**GENOA CHARTER TOWNSHIP
PLANNING COMMISSION
PUBLIC HEARING
MARCH 14, 2022
6:30 P.M.
AGENDA**

Attention:	Kelly Van Marter, AICP Planning Director and Assistant Township Manager
Subject:	Innovation Interchange PUD – Highway Sign Review #1

Attention:	Kelly Van Marter, AICP Planning Director and Assistant Township Manager
Subject:	A&J Cartage – Special Land Use and Site Plan Review #2
Location:	1247 Fendt Drive – east side of Fendt Drive, north of Grand Oaks Drive
Zoning:	IND Industrial District

**Re: A&J Cartage
Site Plan Review No. 2**

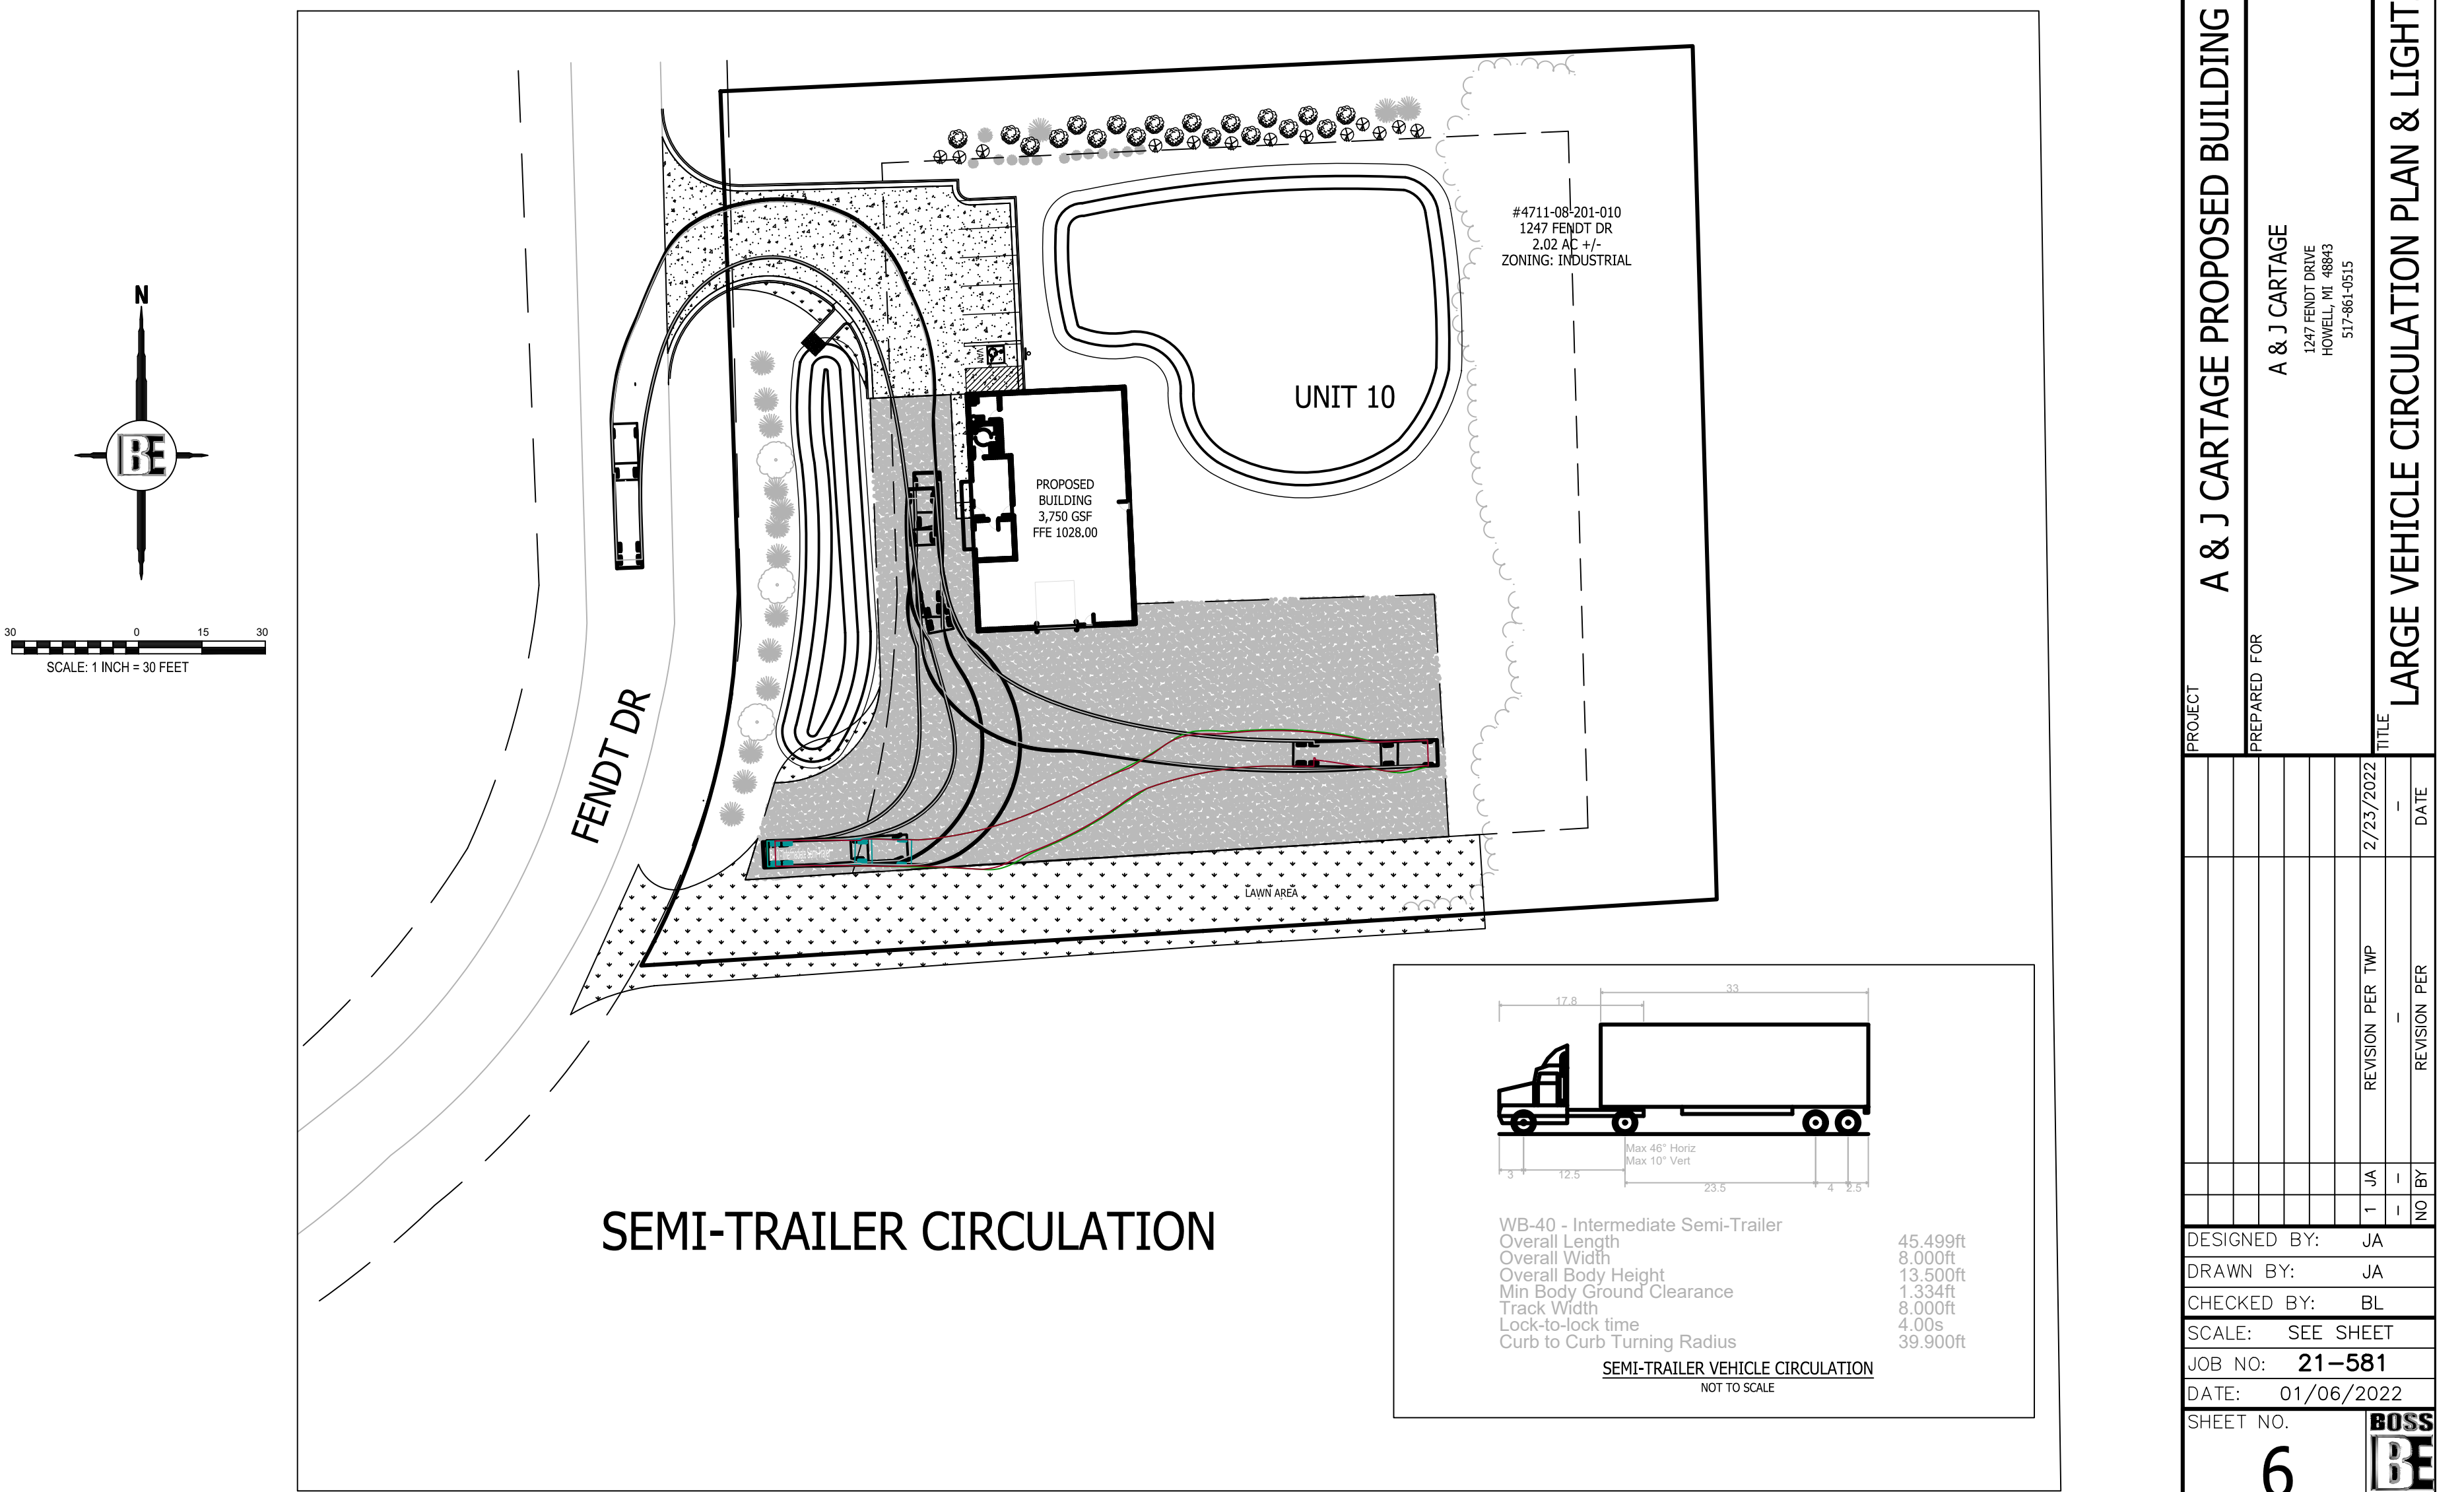
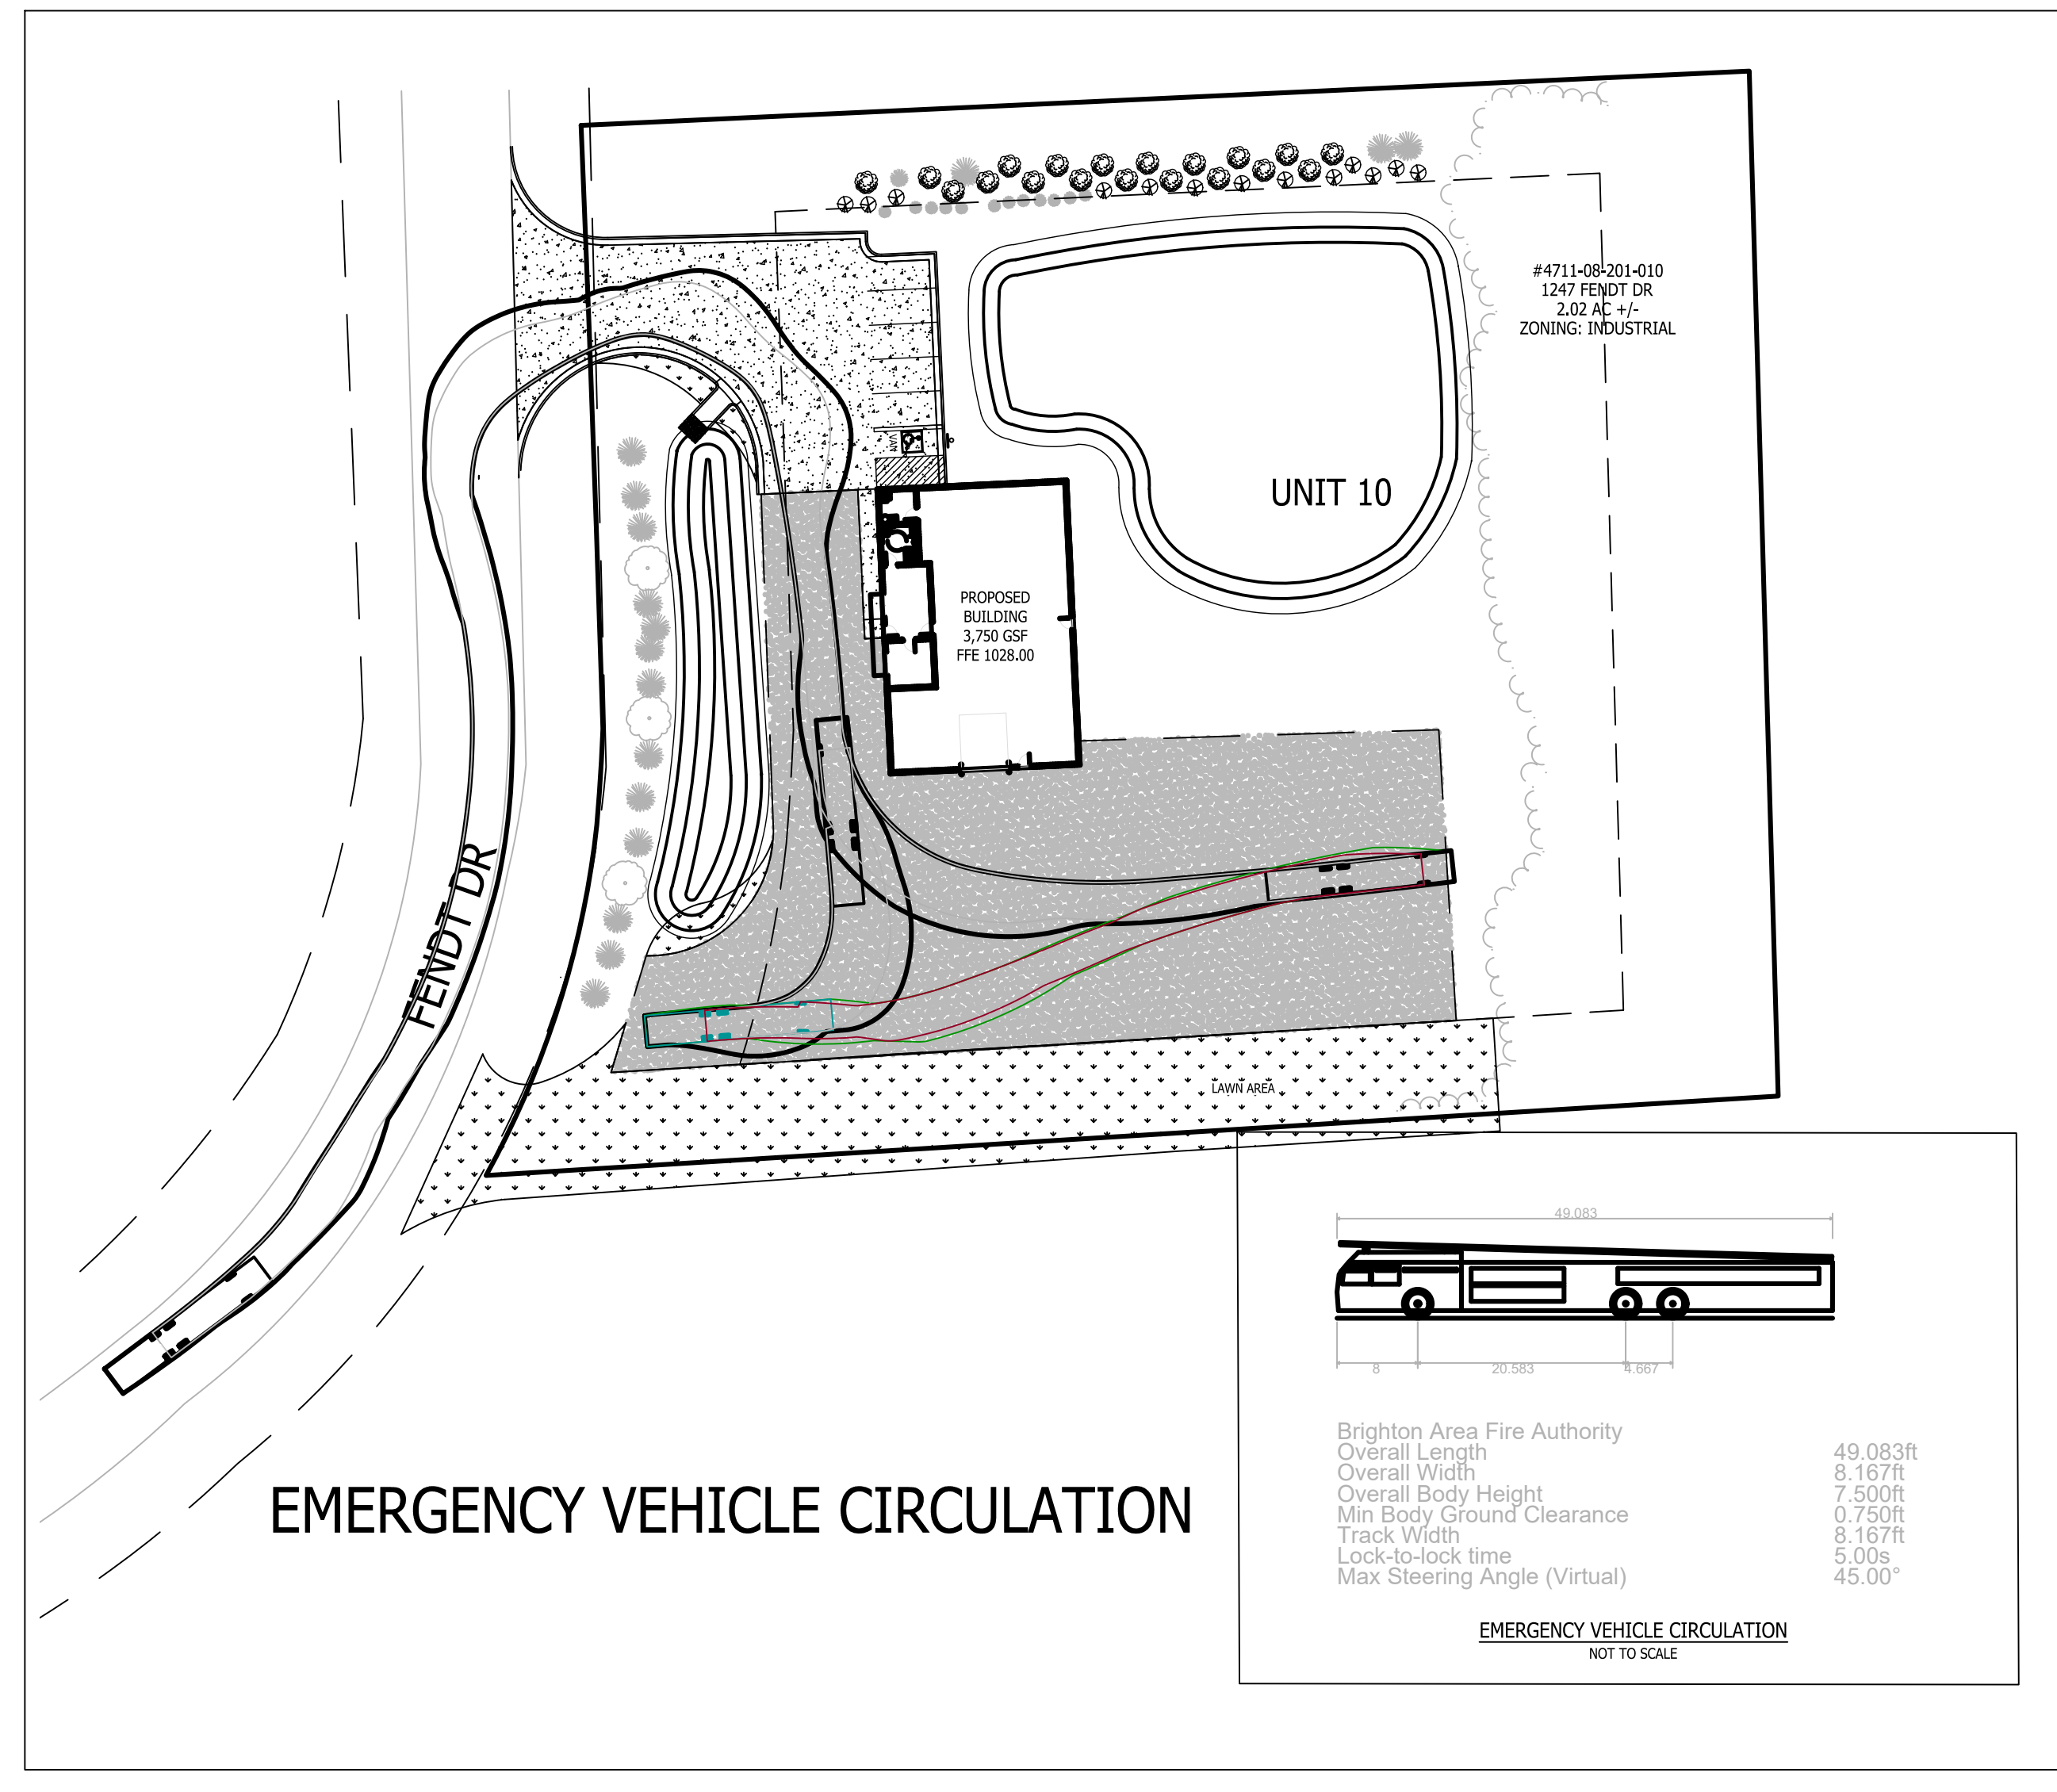
Sheet 6 of the revised site plan includes a truck turning template, depicting on-site maneuvering between the driveway and outdoor storage area.

7. **Exterior Lighting.** Sheet 6 includes fixture details and a photometric plan. The plan includes 3 wall mounted light fixtures that are fully cut off, downward directed LEDs. Mounting heights, fixture types, and light intensities all comply with the requirements of Section 12.03.
8. **Waste Receptacle/Enclosure.** The revised submittal states that the minimal waste generated will be disposed of off-site by the owner, and that, if necessary, curbside pickup will be utilized.
9. **Impact Assessment.** The revised Impact Assessment (dated February 23, 2022) notes that the proposed project is not expected to have an adverse impact upon natural features, stormwater, surrounding land, public services/utilities, or traffic and pedestrians.

EAST (REAR) ELEVATION
SCALE: 1/4" = 1'-0"

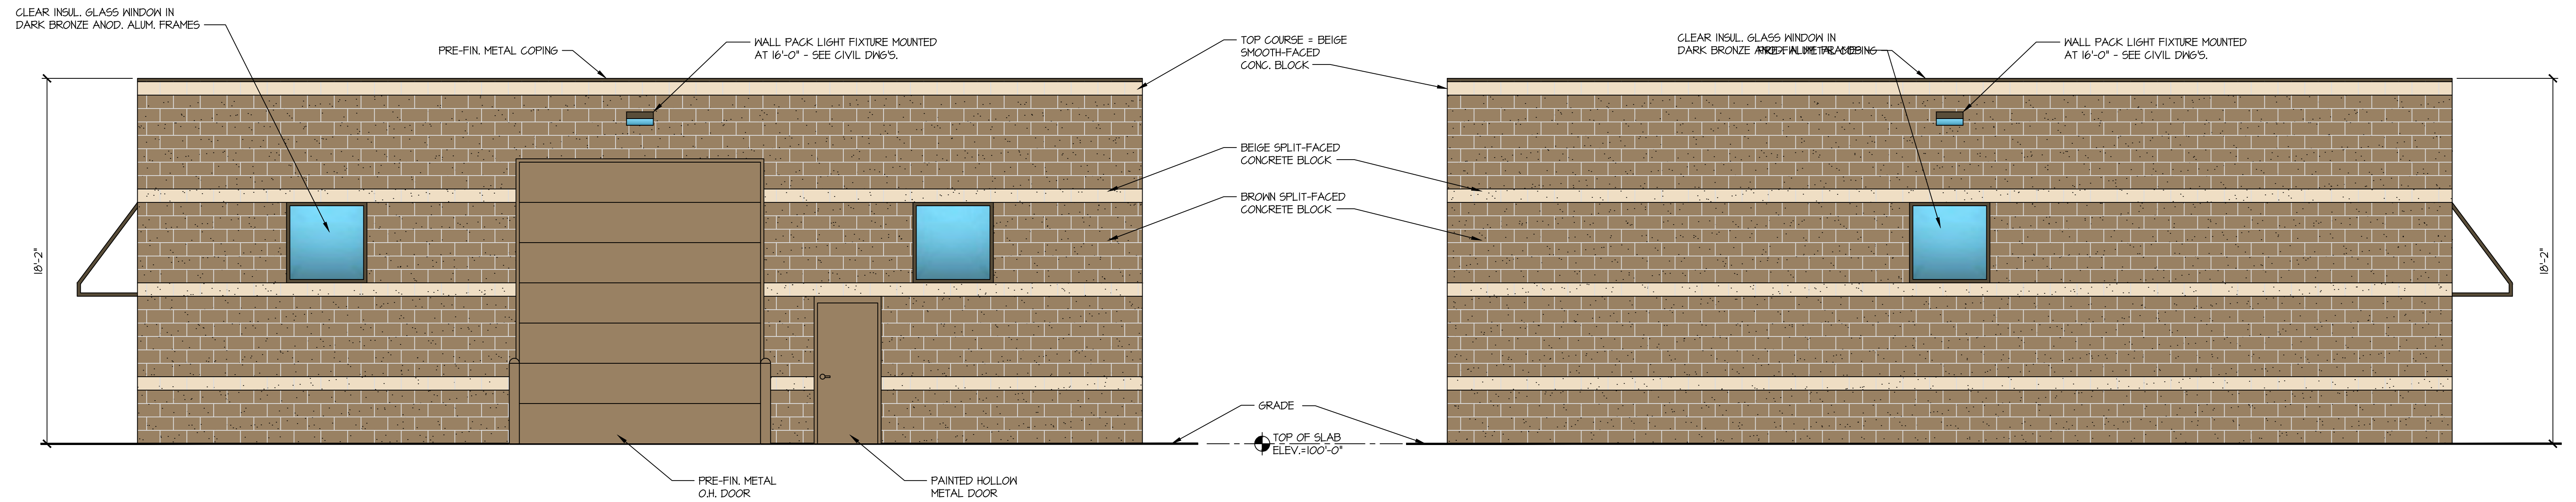
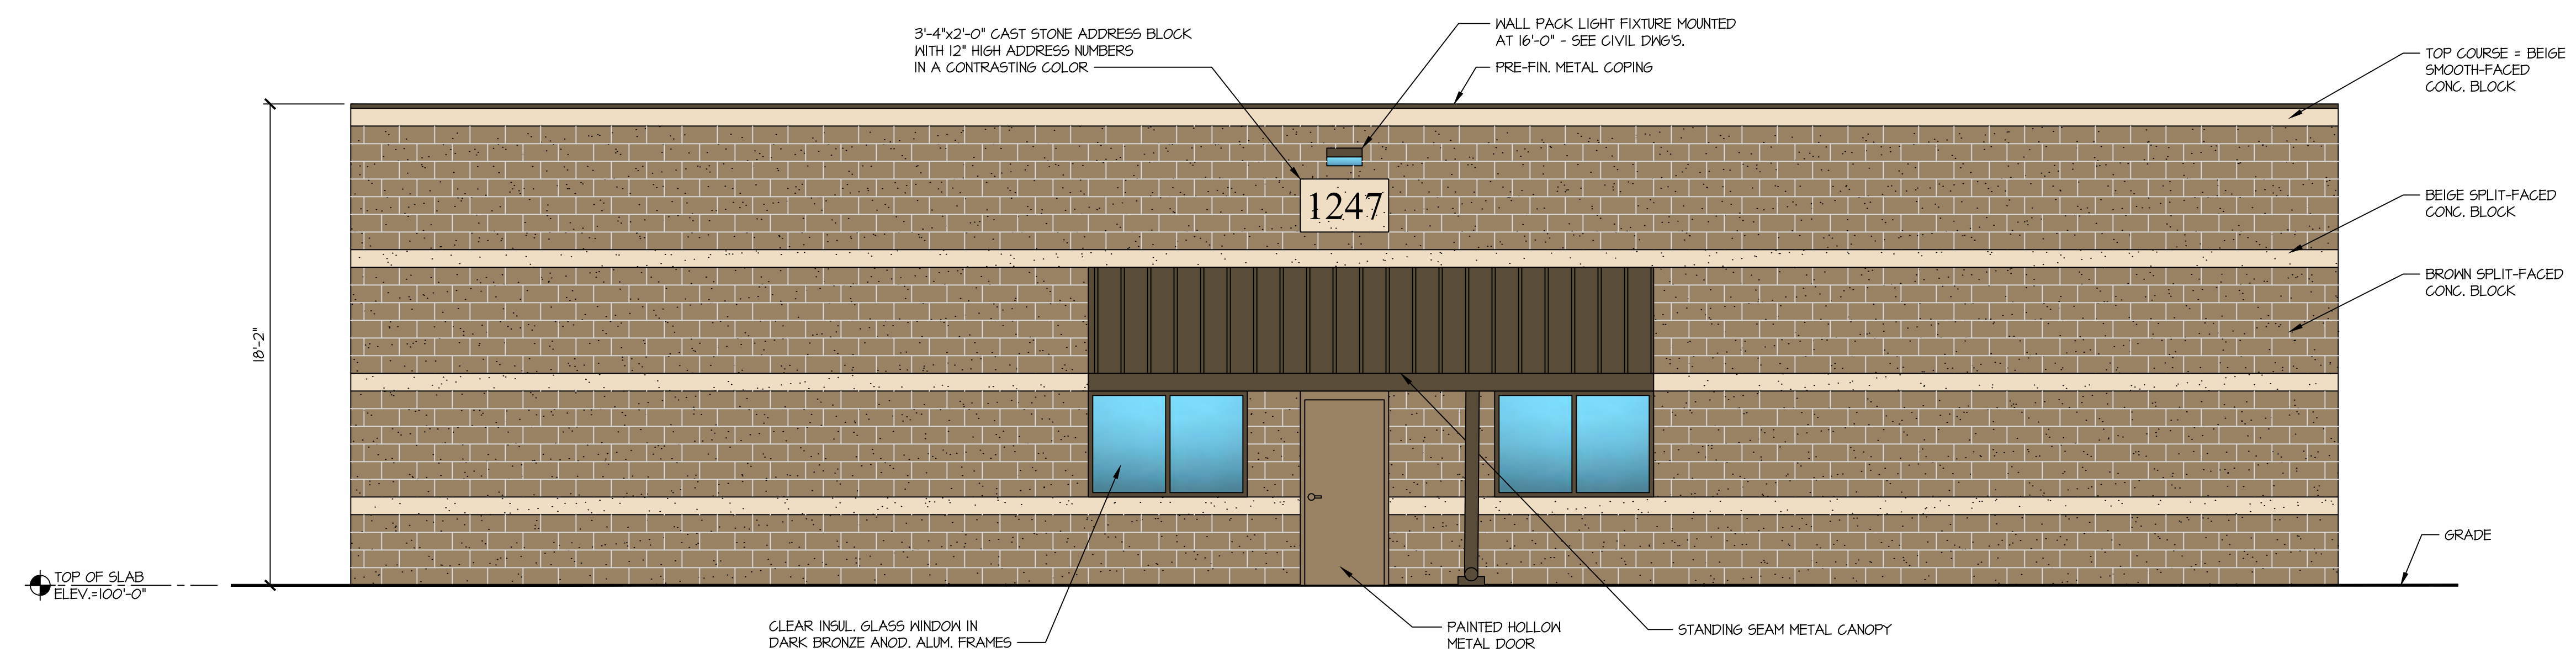
- 2. Building.** Building materials and colors are subject to review and approval by the Planning Commission.

In accordance with the standards of Section 12.01, the revised submittal depicts a building constructed of split-faced concrete block with horizontal bands of smooth-faced block in an earth-toned color palette.
